REFERENCE:	Nova Bus Manuals
SECTION:	12 Interior furnishing
RS N°:	MQR 7621-371, NC 641
EFFECTIVE IN PROD.:	L708-01 (2012SE)

SUBJECT:	Stanchion in the articulation area of the vehicle
JUSTIFICATION:	A break may occur between the mounting plate and the stanchion.

Figure 1 - Typical Stanchion in the Articulation Area

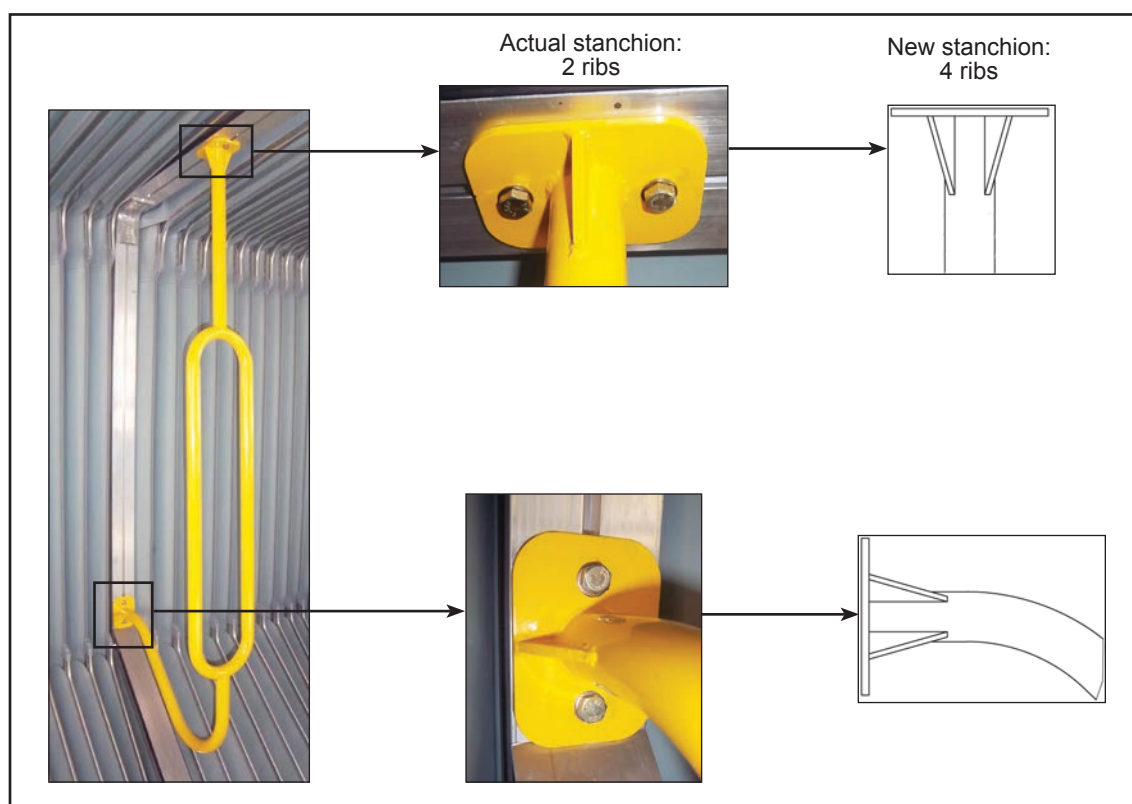
LEVEL	DESCRIPTION	DIRECT CHARGES		TIME
		LABOUR	MATERIAL	
1	Replace the original stanchion with a reinforced stanchion.	Nova Bus	Nova Bus	16 min
2	—	—	—	—

- 1.1 Unbolt the two stanchions located in the articulation area. Retain the hardware. See Figure 1.
- 1.2 Install the new stanchions with the retained hardware. Use blue Loctite thread locker, or an equivalent. Tighten to safely secure the parts in place. ❖
